Certified Action of the City of Raleigh Planning Commission

Case File / Name: S-32-09/ Olde Tower Subdivision

Owner: George Womble
Designer: Baker Engineering Consultants, Inc.

Staff Report

Proposed Subdivision

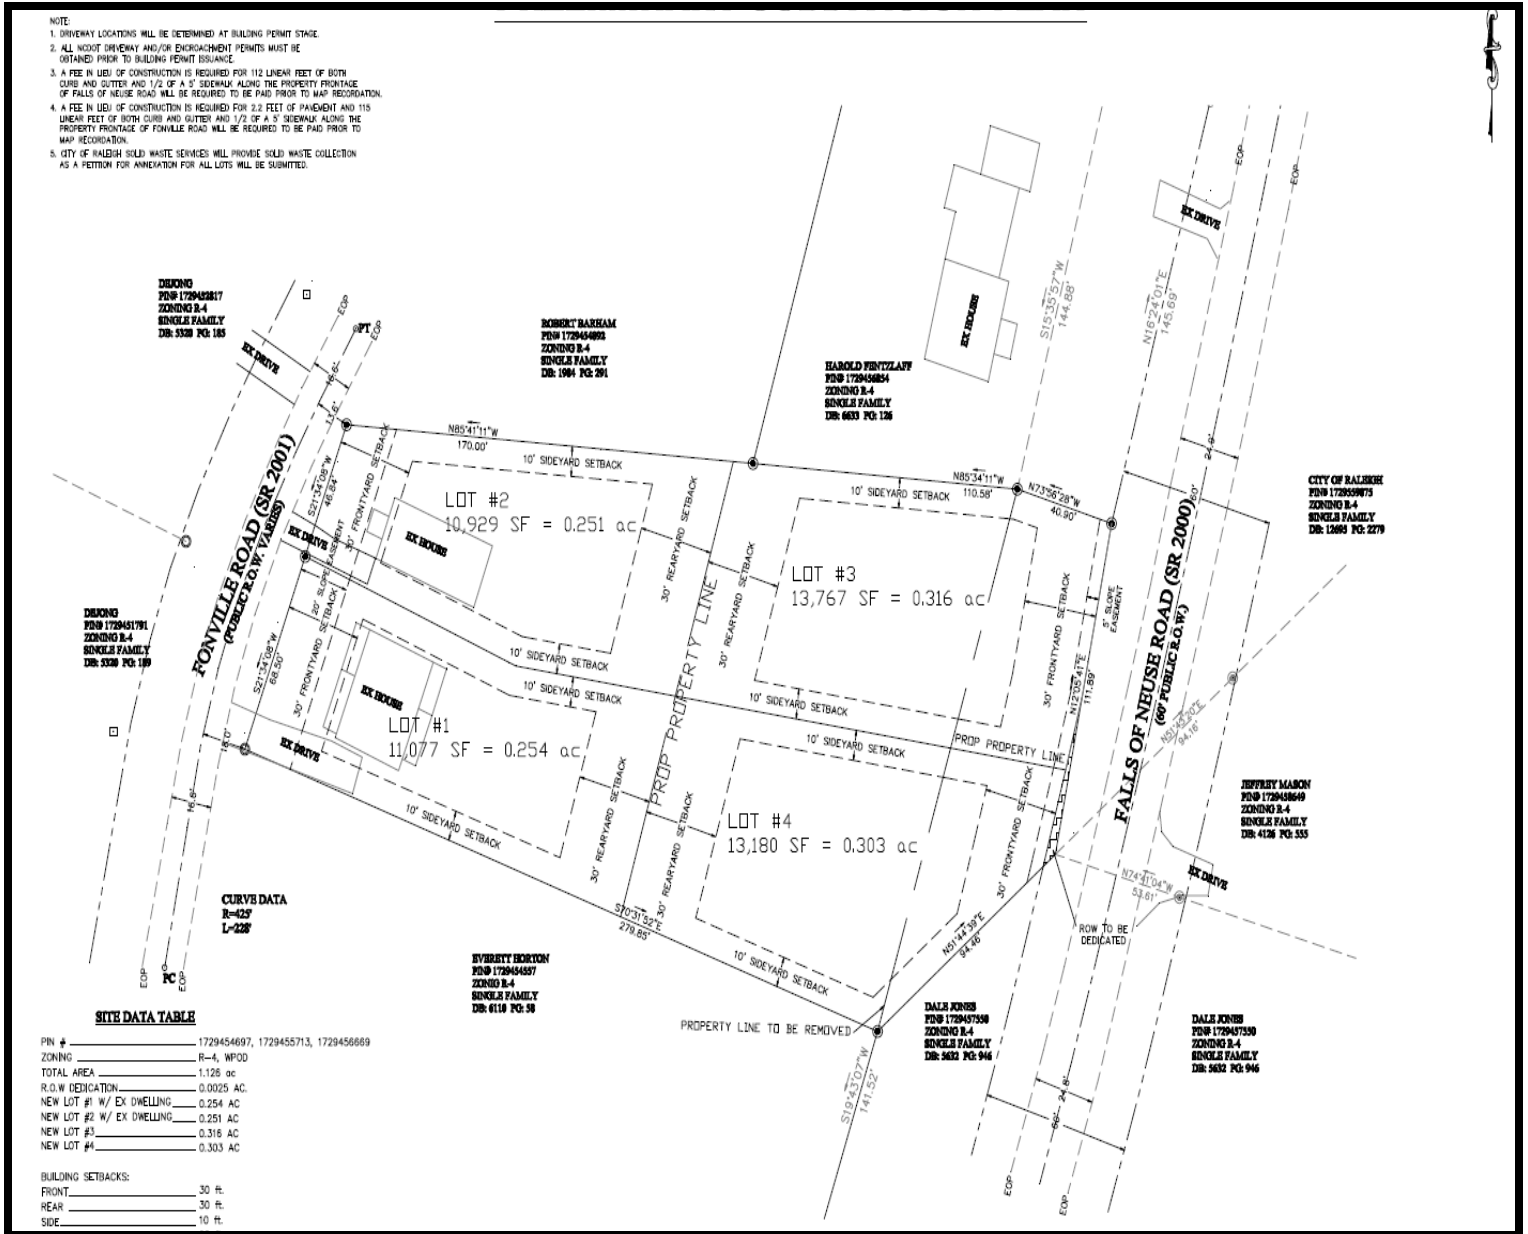
LOT LAYOUT: The minimum lot size in this zoning district is 10,890 square feet. The minimum lot depth in this zoning district is 100' and minimum lot width is 65'. The minimum lot size proposed in this subdivision is 10,929 square feet. The minimum lot frontage in this subdivision is 33 linear feet.

This is an infill subdivision as defined in Section 10-3003. The total acreage is less than 5 acres surrounded on at least 66% of its perimeter by developed single-family detached dwellings and the subdivision plan contains lots which are less than 80% the median lot size and less than 80% of the linear frontage of the adjacent lots.

- (1) All *lot* line boundaries *shall* meet all of the *following*:
 - a. Lot lines *shall* be angled from the *street* in a similar manner to the angle that is typical of the surrounding peripheral residential *lots*;
Applicant response: Only one lot line has been extended to create lots #3 & 4 and it is of a similar angle to periphery lots. All other lot lines that connect to existing streets are existing lot lines.

- b. Lots *shall* consist of no more than four (4) lines (front, rear, side, and side) where such a configuration is typical of the surrounding peripheral residential *lots*;
Applicant response: Existing lot #1 had 6 lines, existing lot #2 had 5 lines and existing lot #3 had 4 lines. Proposed lots #1-4 all have 5 lot lines. We are unable to provide any lots with 4 lot lines due to the existing lot configurations. Please note many lots in that area have similar lot configurations.

- c. Lots *shall* not be configured in such a way that building envelopes for houses are placed one behind the other when viewed from the public street, where such a configuration is not typical of the surrounding peripheral residential *lots*.
Applicant response: Building envelopes have been placed in similar locations of periphery lots.

- (2) Lots *shall* be configured to be adequately served by *City* services, allow for access of emergency vehicles, and meet *City* standards for proximity to fire hydrants and fire lines where public water is available.
Applicant response: This subdivision is served by City Services. All lots front on and with drives to the existing public streets, therefore emergency vehicles will have access. Public water mains run along the fronts of the 4 lots of the subdivision. The 2 existing houses to remain on Fonville Road are already connected to public water and sewer. Public sewer will be extended to provide service to the 2 new lots (lots 3 & 4) fronting Falls of Neuse Road. The 2 new lots (lots 3 & 4) will have water services from the existing water main along Falls of Neuse Road. A Fire Hydrant will be added along Falls of Neuse Road.

Applicant response: Lots are sized so they cannot be subdivided again with current zoning.

STORMWATER MANAGEMENT: This subdivision will utilize a shared underground pipe detention system to meet stormwater quantity control regulations for only lots #3 & 4. No stormwater quality BMP is being utilized but a NCEEP buydown payment will be required to meet stormwater quality control regulations. This subdivision is also in an Urban Water Supply Watershed and will limit impervious surface areas to 24% on all

- (1) That the Planning Commission finds that this infill subdivision meets the lot layout standards of Section 10-3032(d);

- (2) That construction plans for the stormwater detention systems be submitted and approved by the Public Works Department;
- (3) That the City Attorney approves the (~465 linear feet) off-site sanitary sewer easement deed for the City of Raleigh sewer extension from DB 6633 PG 126 and DB 00195 PG 0017 property located north of the subdivision and that the deed of easement be recorded with the County Register of Deeds office. A recorded copy of the document must be provided to the Public Utilities Department;

- (16) That the City Attorney shall approve a restrictive covenant stating that lot 3 shall have a maximum impervious surface, as defined in Part 10 Chapter 9 of the Raleigh City code of 3,304 square feet. Lot 4 shall have a maximum
